Title: n-DAP		SIZE	
Status	status	Assembled	asern
PCB	pcb	CODE	code
Designed	designer1	Reviewed	reviewer1
Creation Date:	created	Updated:	18/10/2017
FILE NAME: N-DAP.SchDoc		Rev	
Creation Date:		Updated:	
Created		18/10/2017	
Sheet		1 of 1

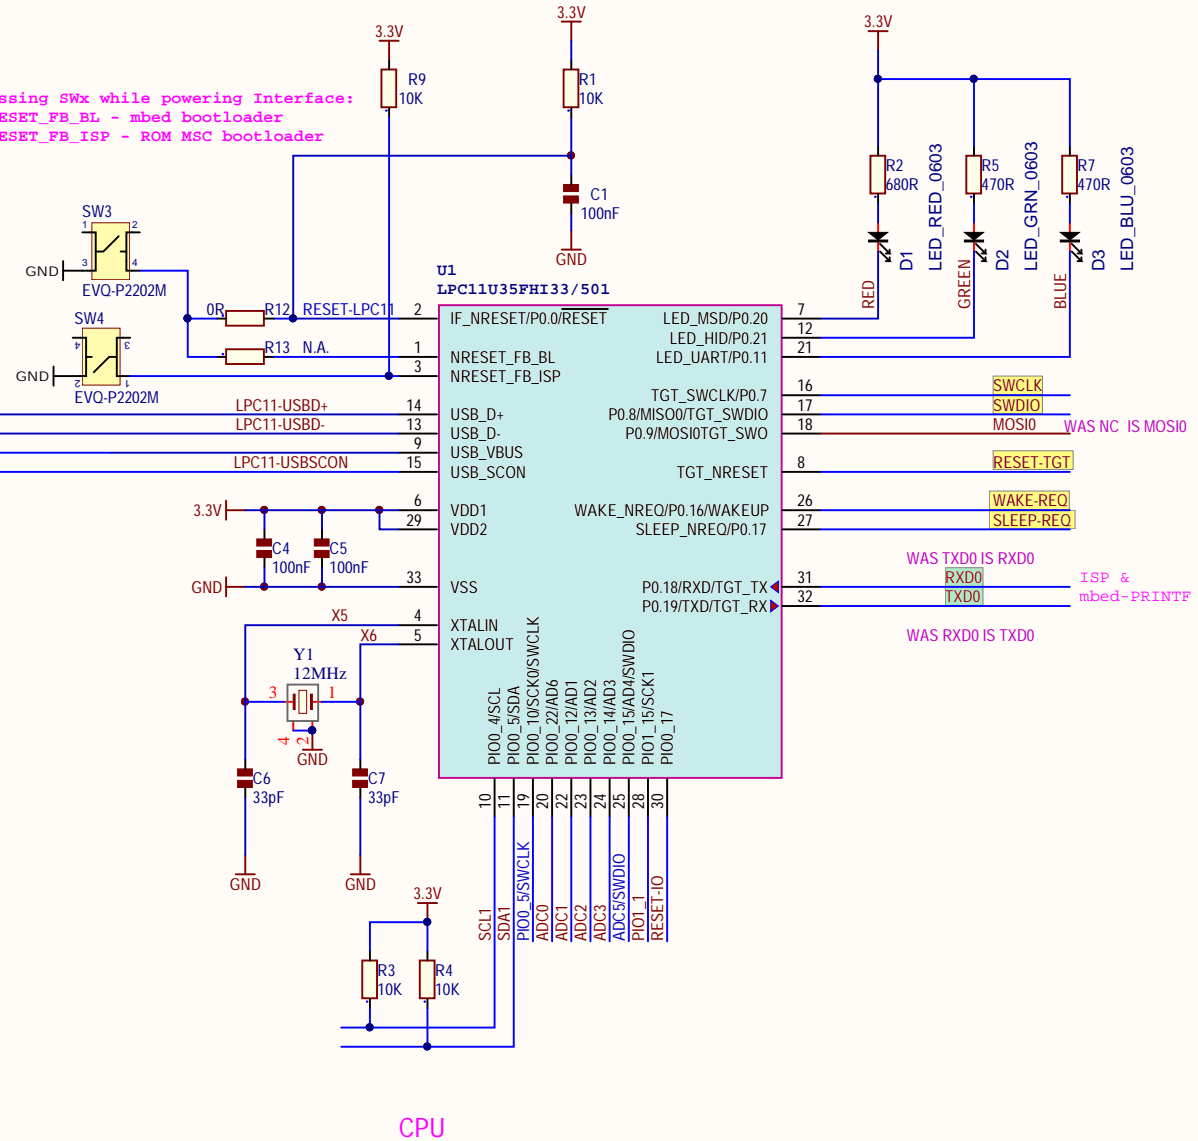
TODD:
TEST IF R9 FIXES THE "ALWAYS TO ISP AFTER RESET" ISSUE
BY SOLDERING A 10K PULL-UP
